RE: A.L.R.T. DEVELOPMENT IN BURNABY

TO: MUNICIPAL MANAGER 1981 DECEMBER 29  
FROM: DIRECTOR PLANNING & BUILDING INSPECTION PLANNING DEPARTMENT  
SUBJECT: A.L.R.T. DEVELOPMENT IN BURNABY

RE: A.L.R.T. ALIGNMENTS AND STATION LOCATIONS IN BURNABY

SOURCE: CONTRACT SPECIFICATION VOLUME II (CONTRACT DRAWINGS). FIG. 1

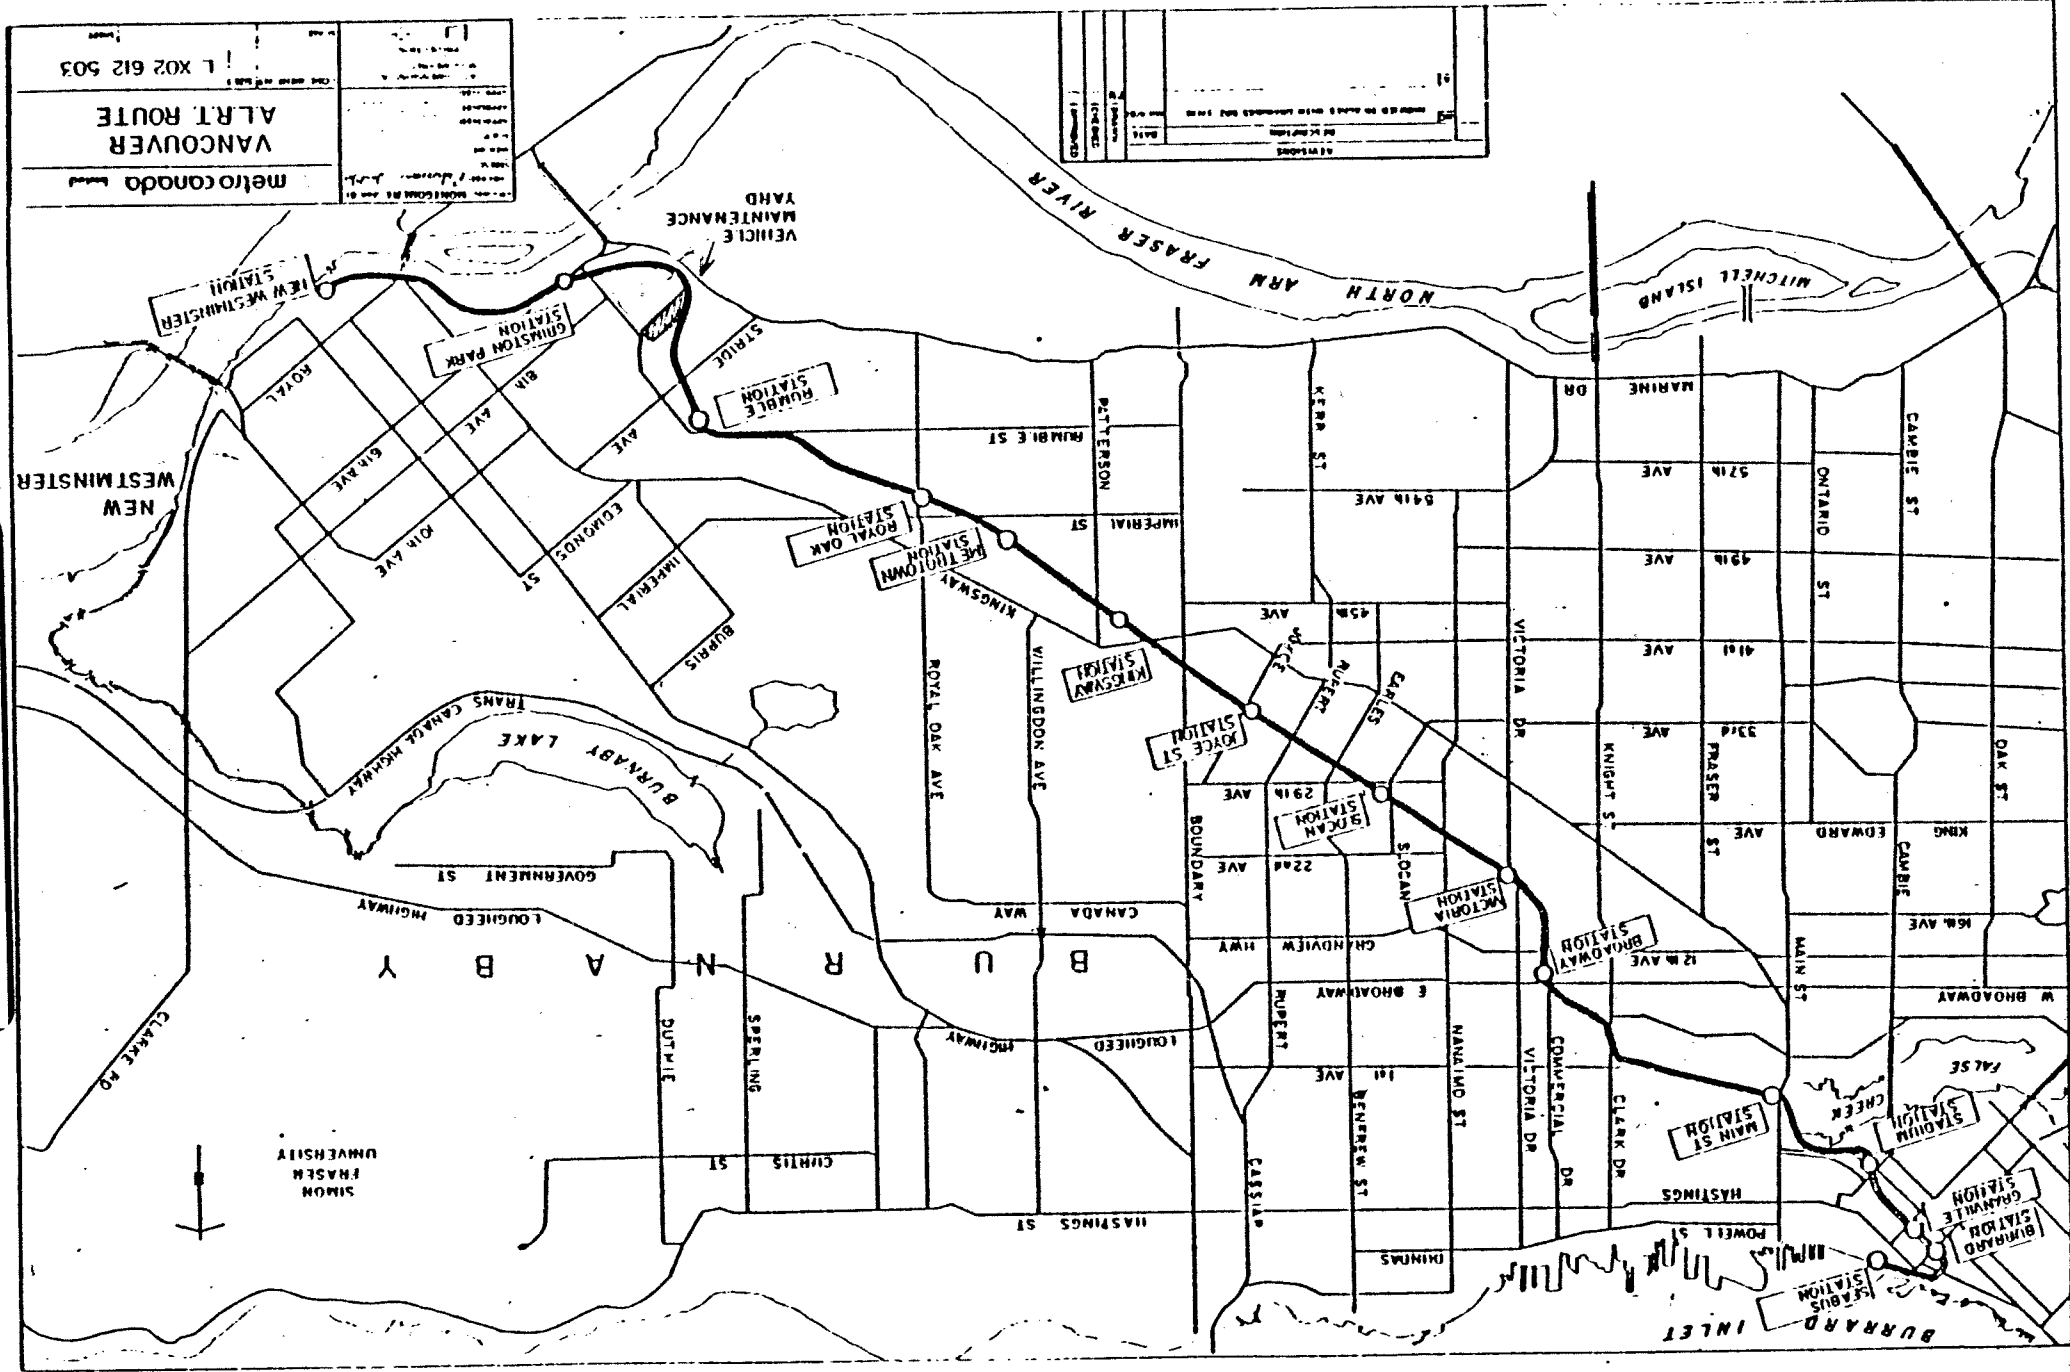
As part of the contract for construction of ALRT, the UTA has specified an alignment plan with station locations. This alignment plan substantially accords with the LRT alignment previously considered and is shown on Fig. 1 attached. This alignment is considered a baseline against which the cost of substantial changes to the design of the system will be judged. The baseline system, which is used to gauge the extra costs, should adequately meet fundamental system requirements which, inter alia, must include the needs of respective Municipalities.

FIG. 2

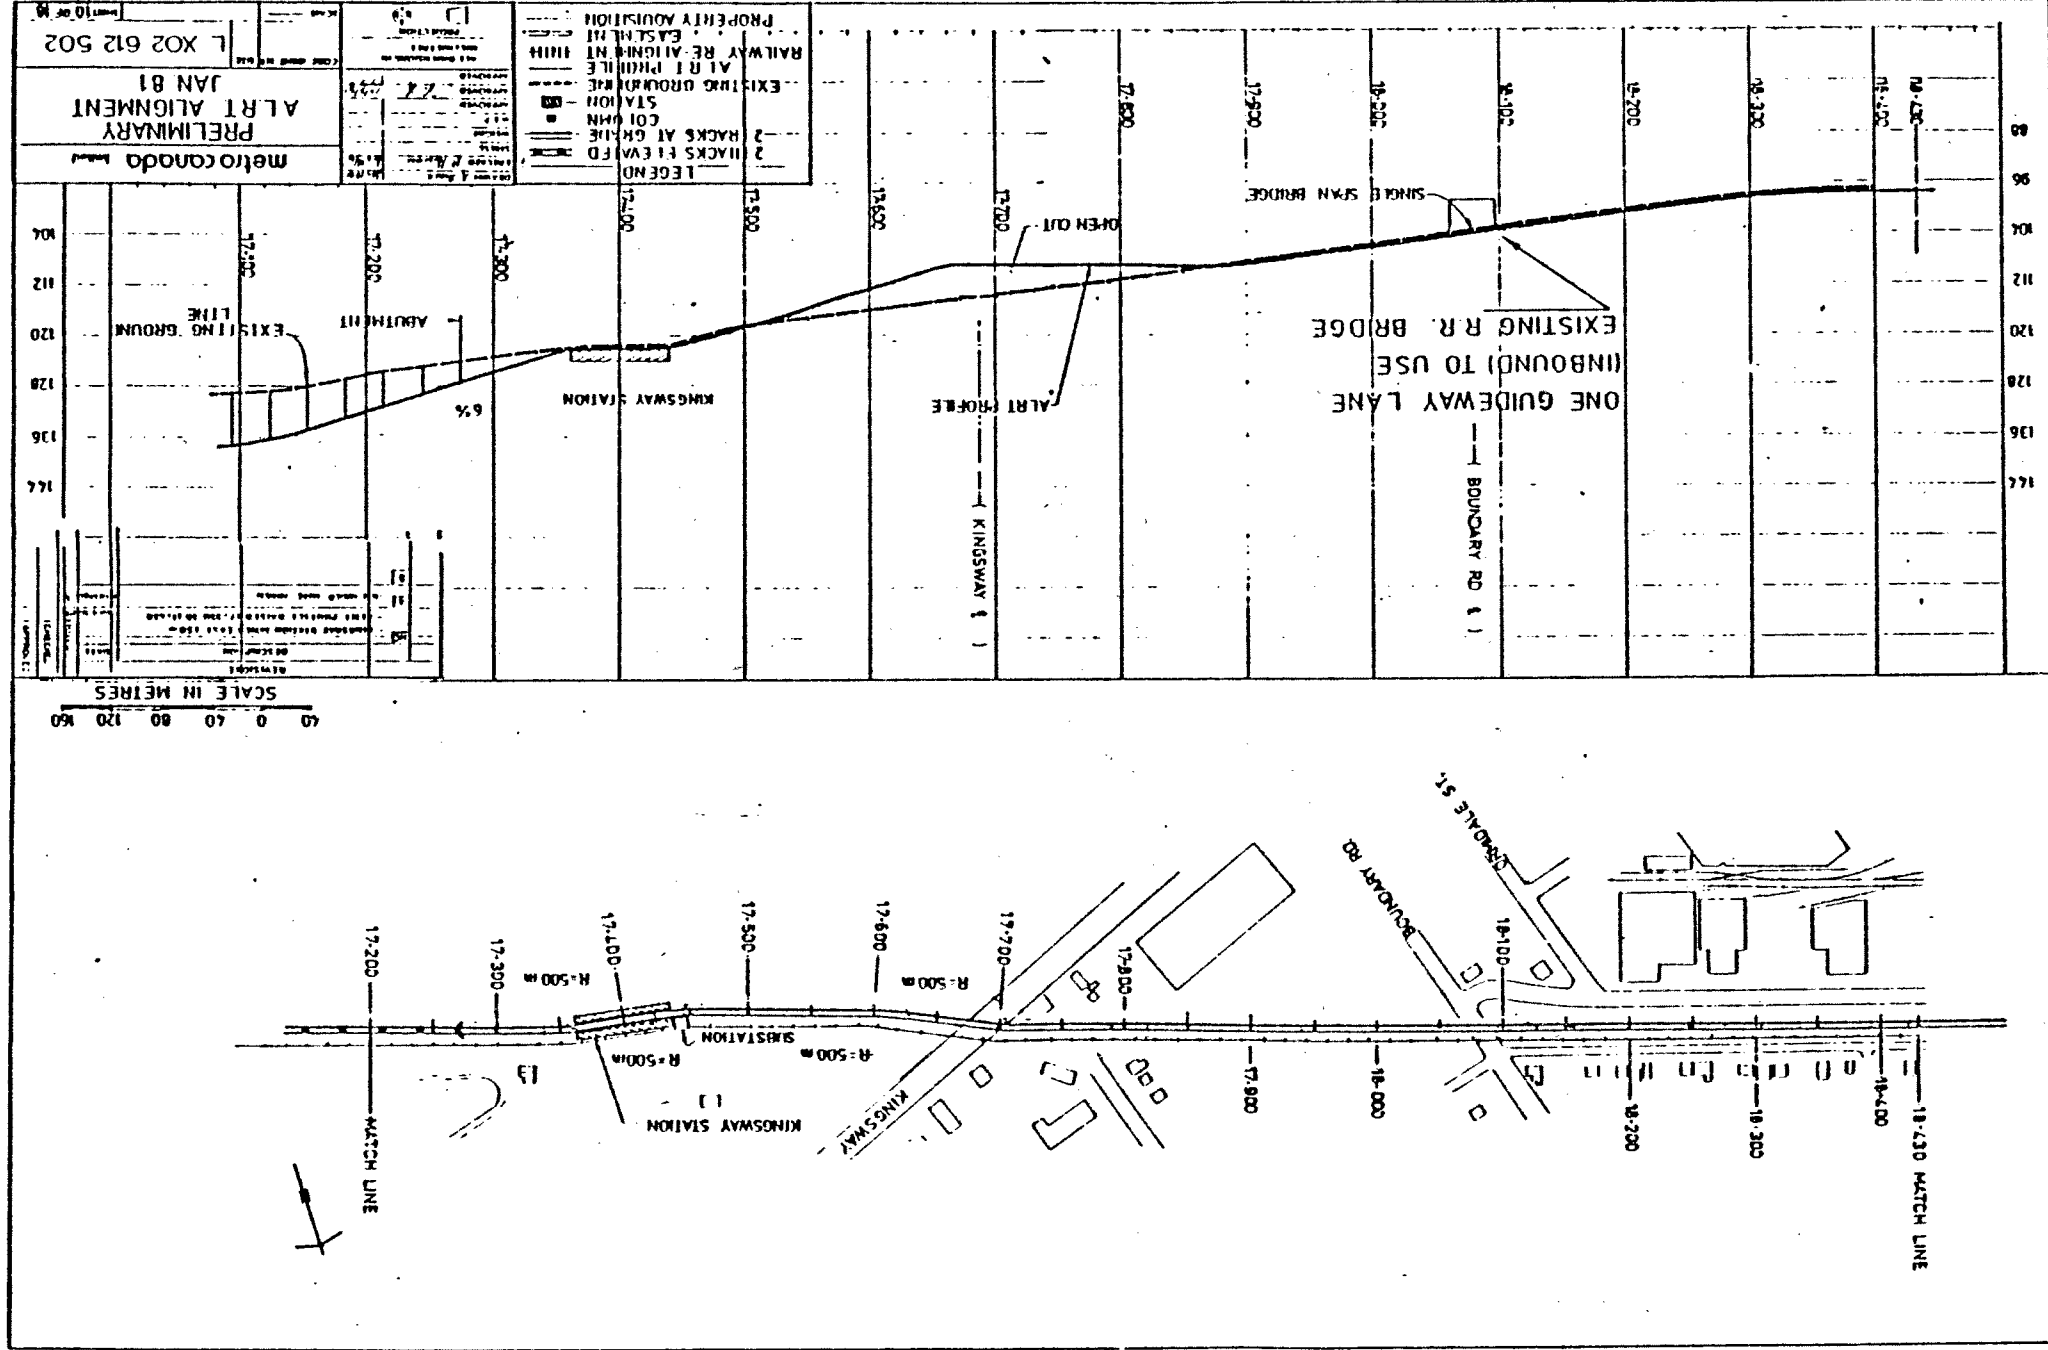
In its original consideration of A.L.R.T. Council recommended locating stations at both Smith and Patterson on either side of Central Park. Although the G.V.R.D. Rapid Transit Project considered these locations as alternatives the U.T.A. base line specification shows a single station in the middle of the park at grade. Whilst such a location may be considered a compromise to replace the two stations endorsed by

Burnaby Council it is our view that such a compromise does not serve Burnaby as adequately as the two stations at Smith and Patterson or indeed as adequately as a single station located at either Smith or Patterson. The U.T.A. supports a single station in order to minimize their costs. The at grade station that they have proposed would be cheaper than a station in cut at Smith or one that is elevated at Patterson. From an operational point of view they prefer one station because each additional station slows the system down, and during peak hour service each additional station requires an additional train in order to maintain line capacity.

Municipal staff support the two stations as originally endorsed by Council because of the development potential and increased service to the Metrotown regional centre. Should only one station be provided now, then it should be either at Smith or Patterson rather than in the park thus making the station more accessible whilst allowing for the addition of a second station at a subsequent date. In this regard, the station at Patterson rather than Smith is preferable for first phase construction because it will assist the concentration of Metrotown development in the primary core area and serve the high density housing now being developed East of Central Park.

The UTA has proposed a station location, at grade, south of Kingsway within Central Park (see Fig. 2). In its previous consideration of the LRT study Council endorsed station locations bracketing Central Park at Smith Avenue north of Kingsway and at Patterson. In the preliminary plan for LRT the GVRD considered the station at Smith as an alternative to the one at Patterson because of the proximity of the two station locations. Clearly the location specified by the UTA was chosen as a compromise. Staff have requested that the UTA include both Council endorsed station locations in the baseline specification. Nonetheless it is considered that the number and location of stations in this vicinity should be further evaluated when there is a firm indication as to the final location of adjacent stations in Vancouver and the Metrotown core area. Pending this evaluation the option of having stations at both Smith and Patterson should be maintained.

3.1 The A.L.R.T. base line specification for A.L.R.T. should include stations at Smith and Patterson rather than one station in Central Park.

3.2 If only one station is to be provided now in the vicinity of Central Park then Patterson is the preferred location and the A.L.R.T. system should be built so as to accommodate a future station at Smith.

FIG. 4

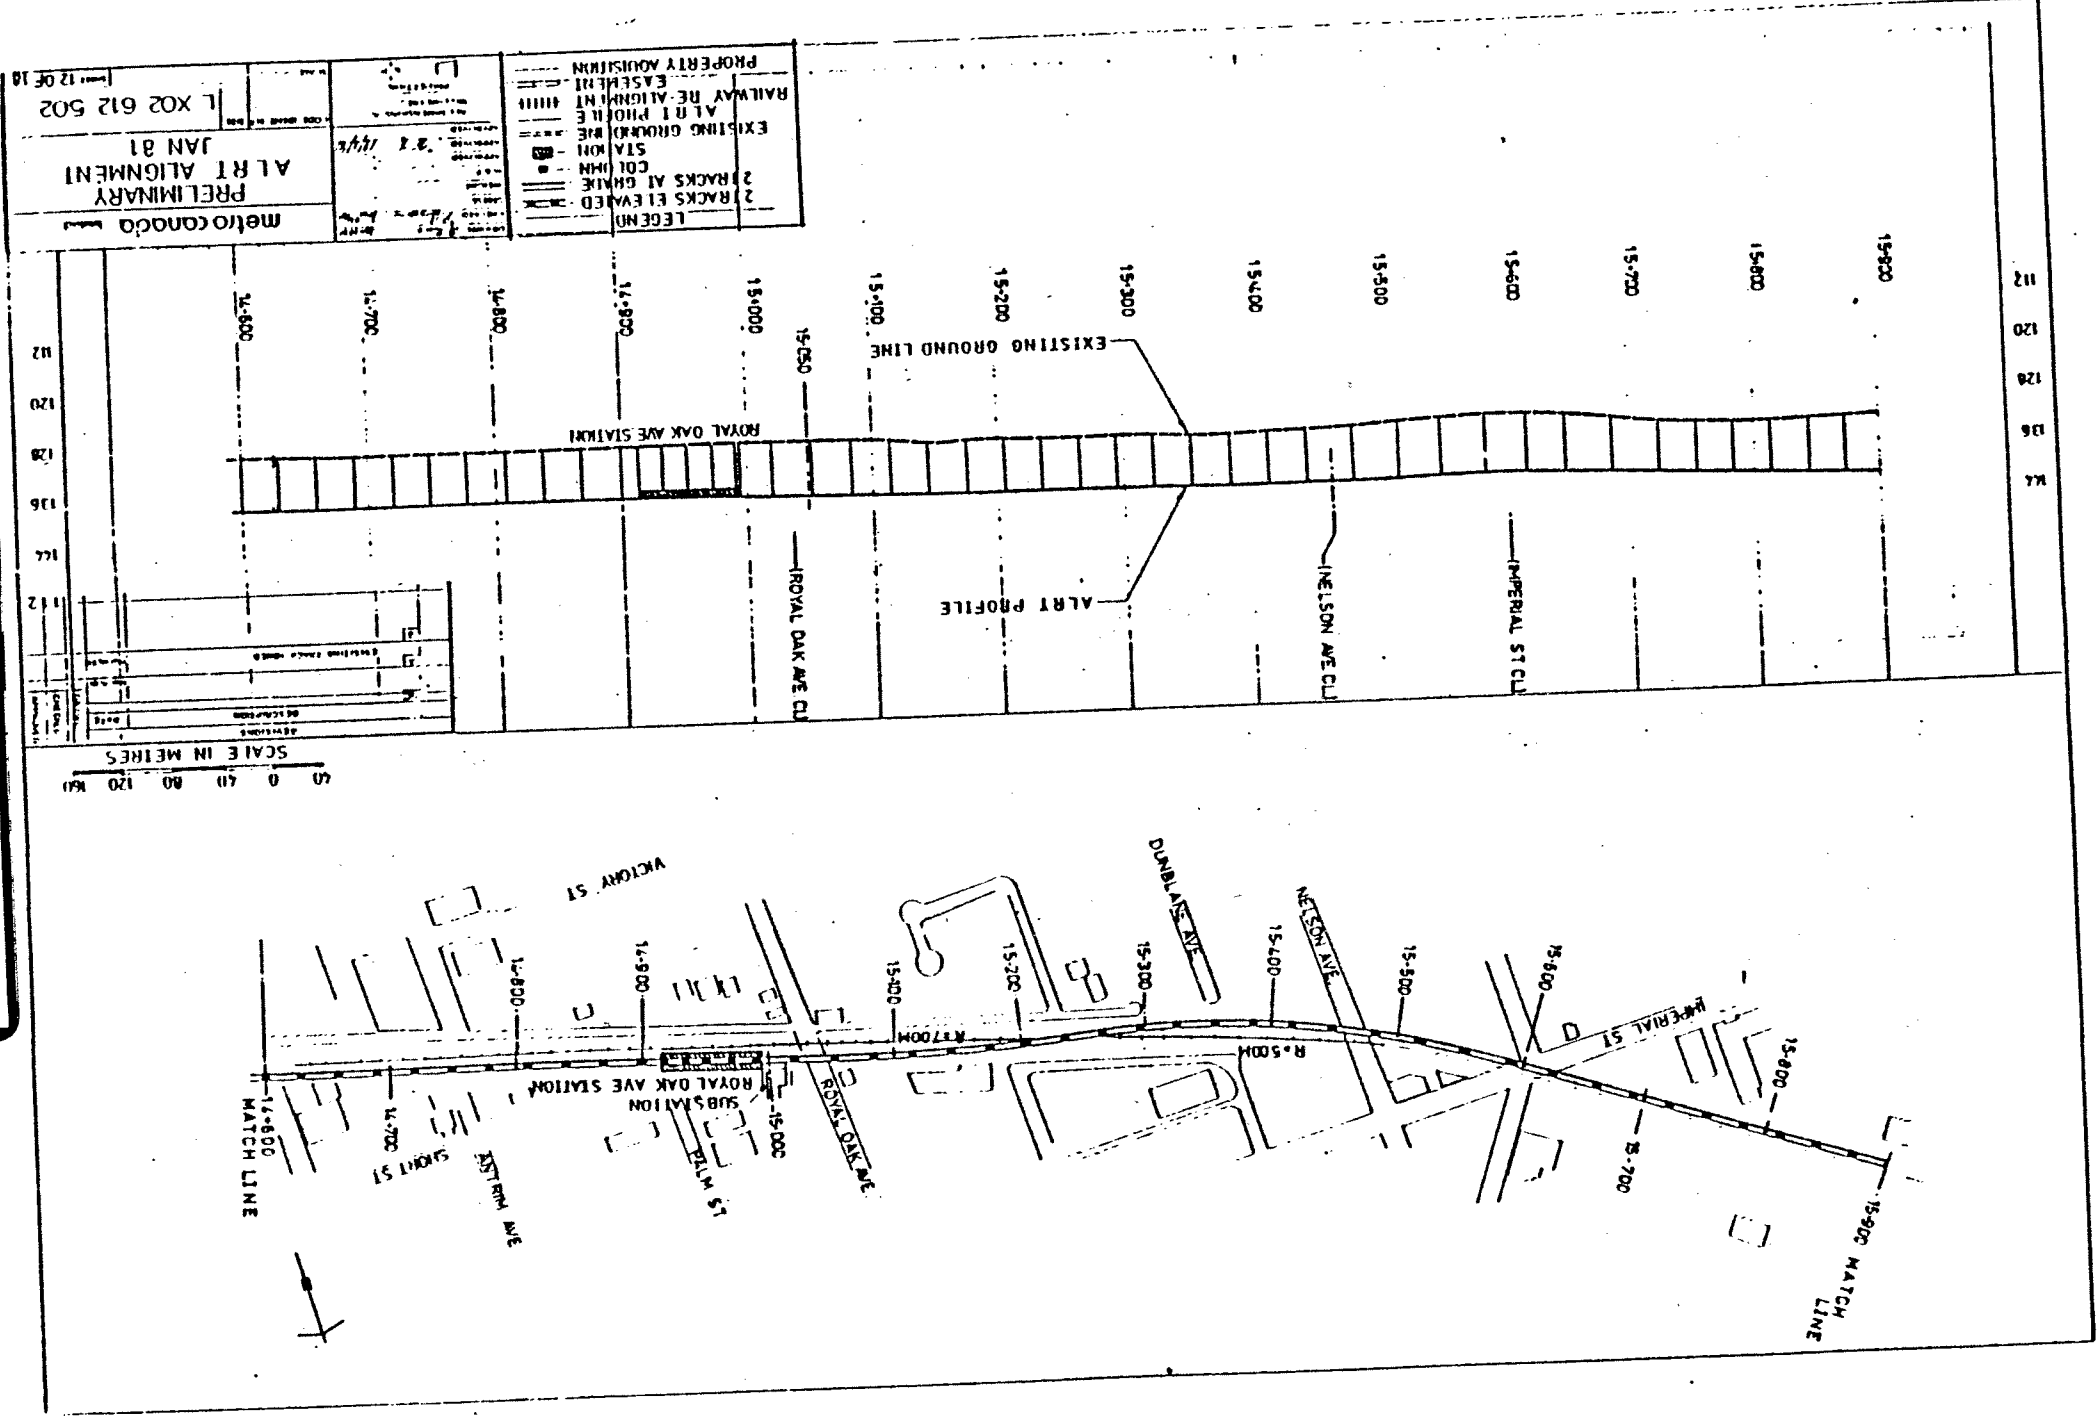
The alignment specification indicates that the LRT station is to be sited (Fig. 4) in accordance with the GVRD's preliminary design for LRT as endorsed by Council. The greater flexibility afforded by the aerial alignment for ALRT suggests that further consideration should be given to the precise siting of the station at Royal Oak. For example a station straddling the Royal Oak right-of-way might offer greater ease of access. It is presumed that such minor adjustment to the micro location of a station would be accommodated within baseline costs.
